April 21, 2021
20566

Windham Public Safety Rénovation and Expansion Project

Review Comments and Responses:

FLOOR & ROOF
PLAN &
BUILDING SECTION

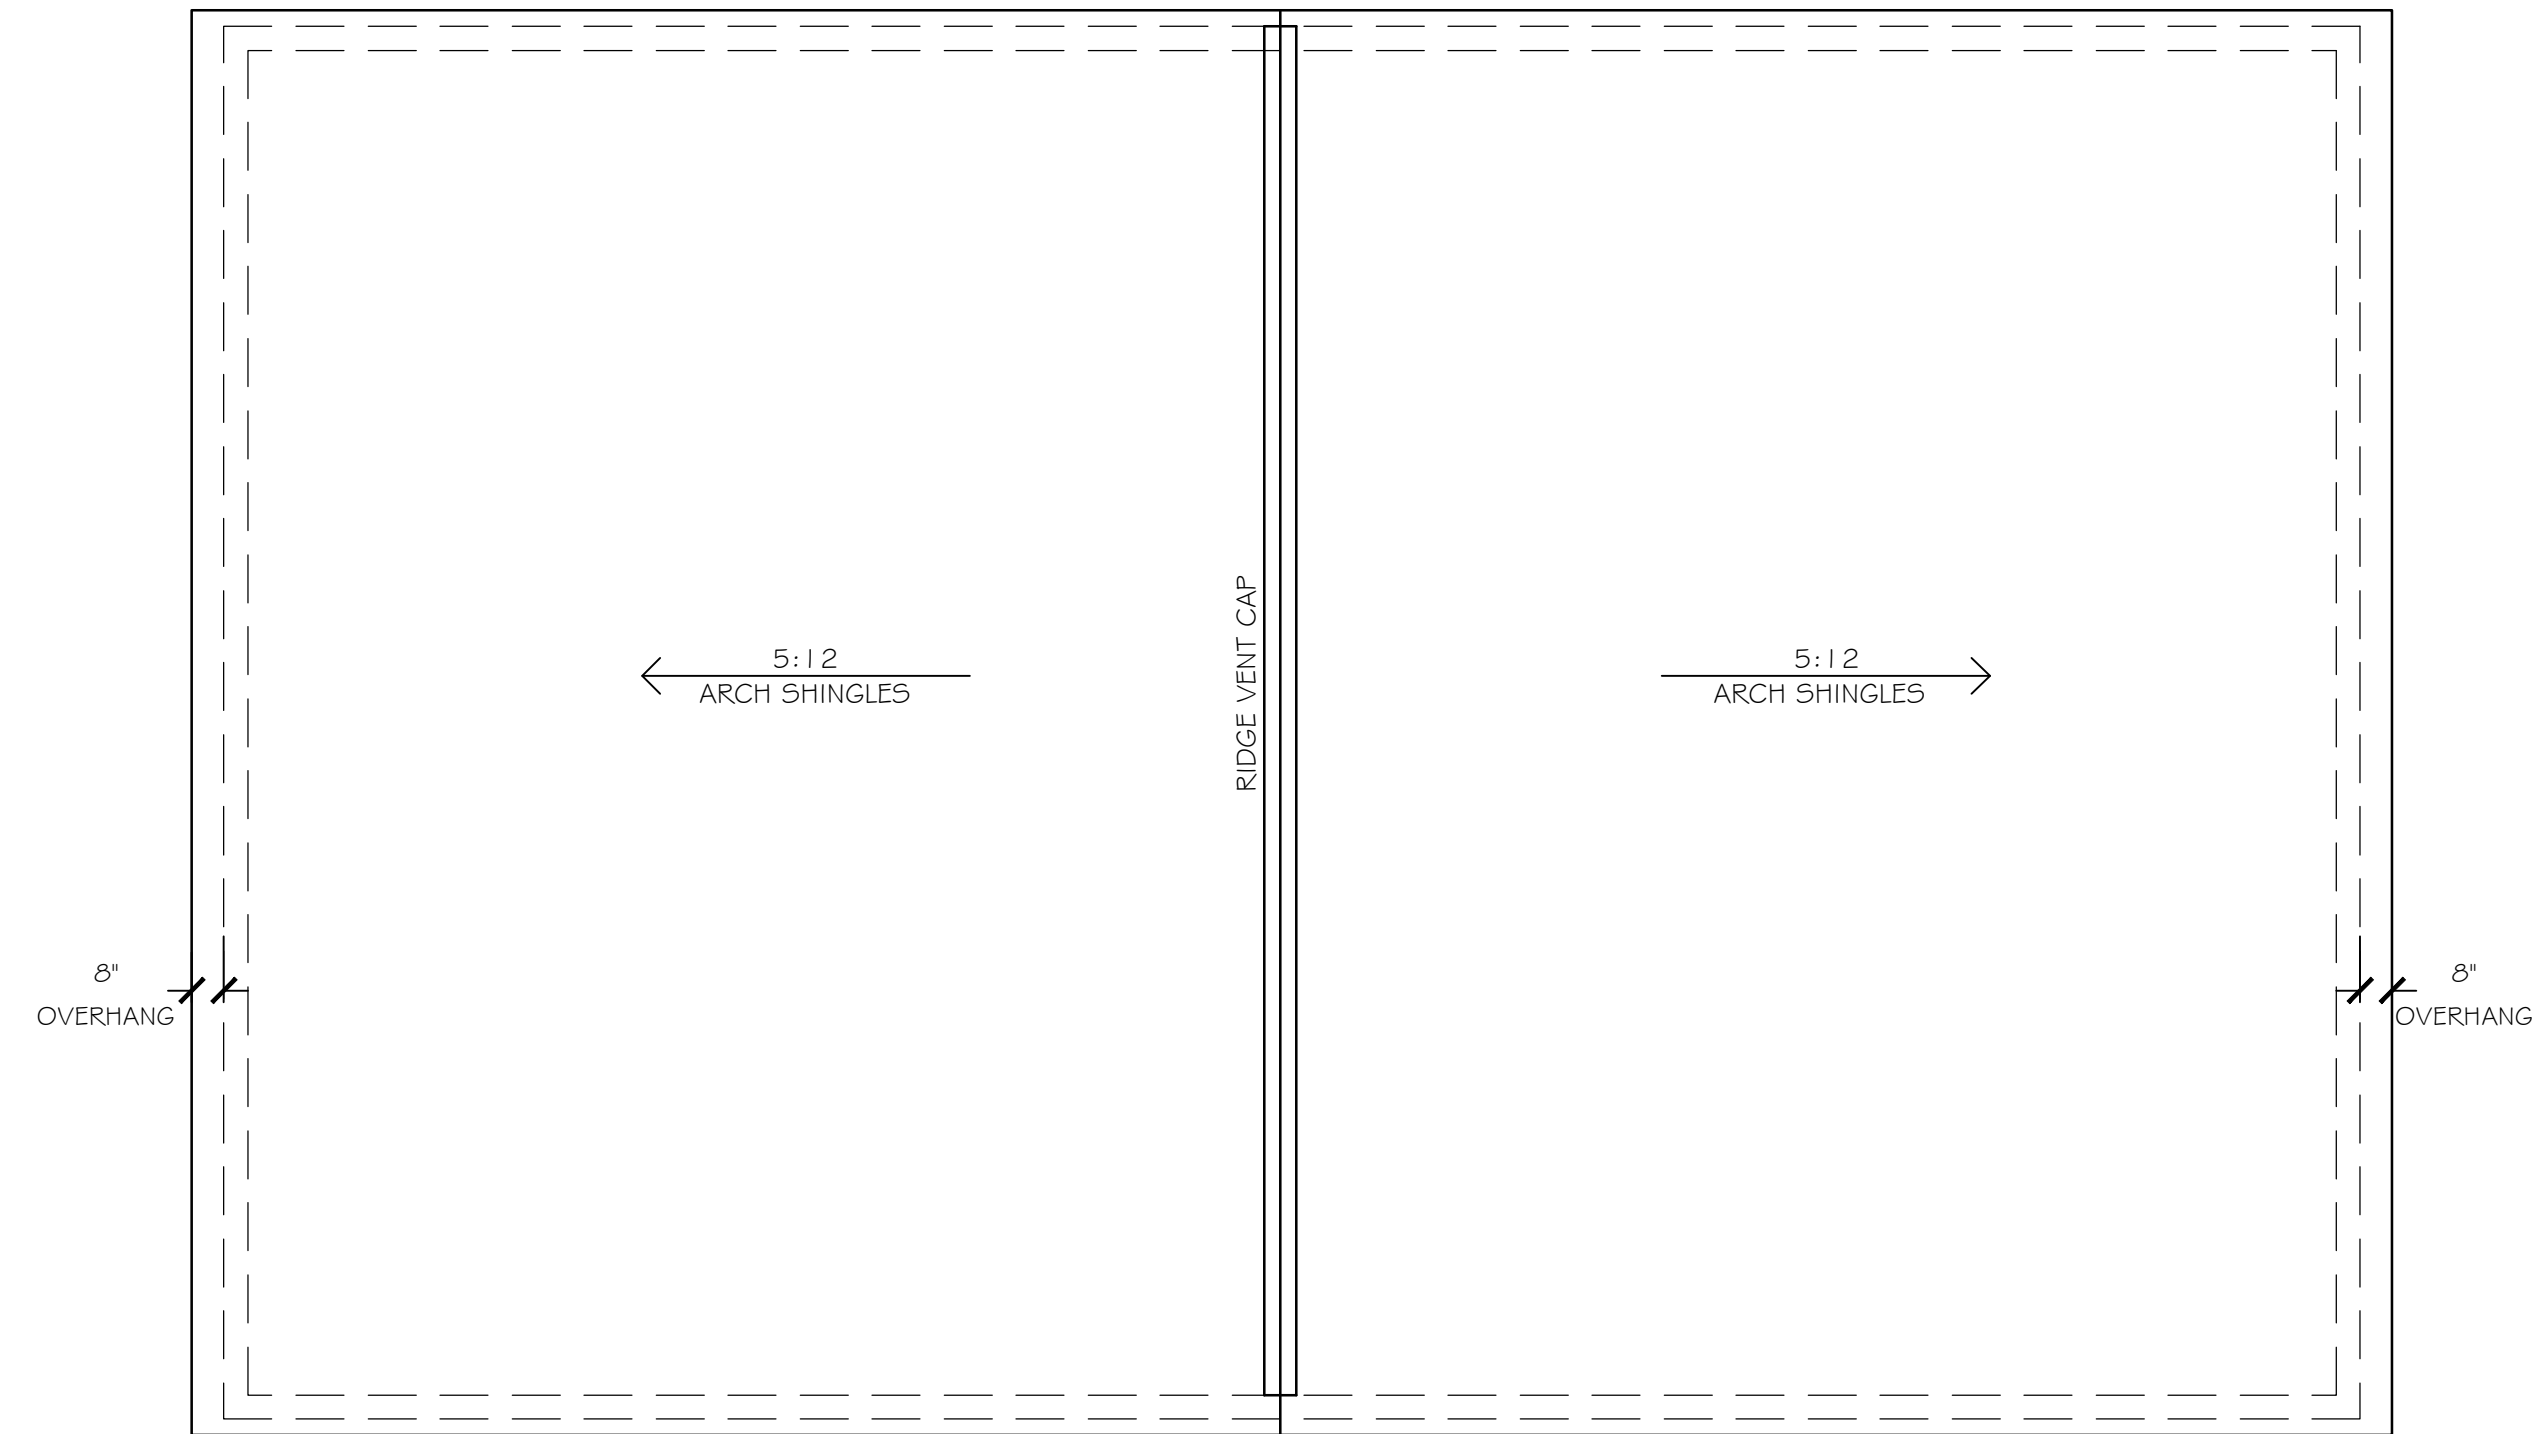
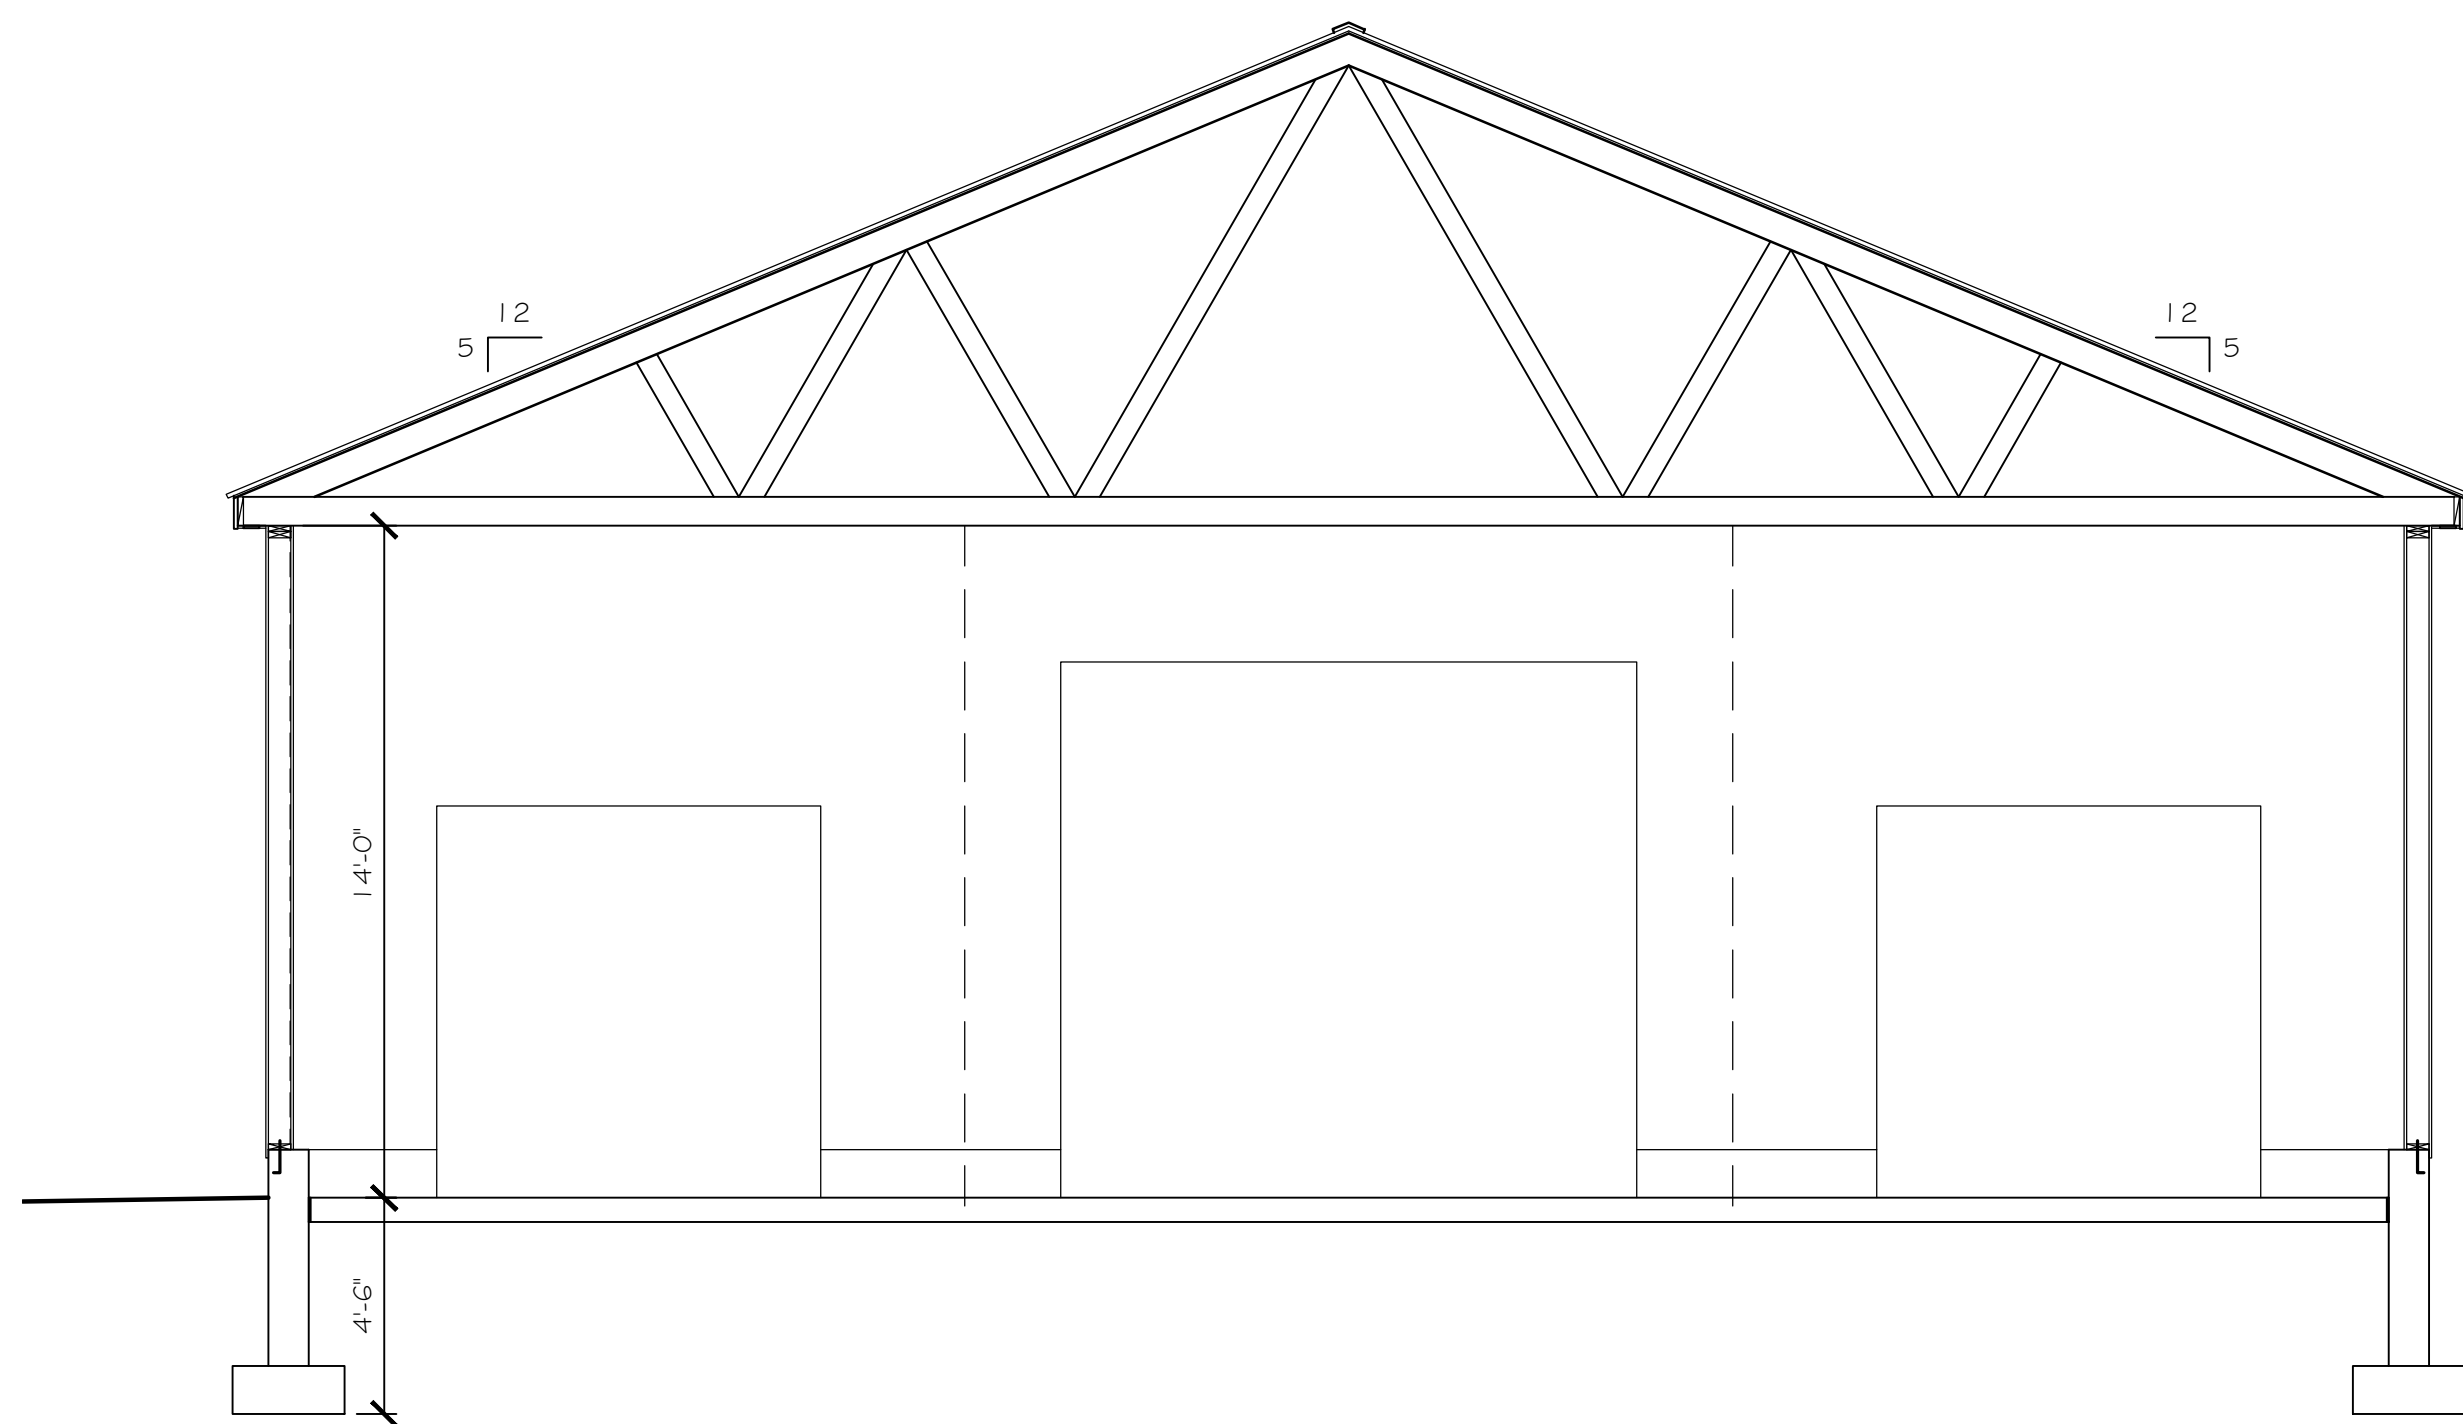
5. Ground floor elevation drawings for the proposed evidence storage buildings.

Response: We have included the architect's plans for the building.
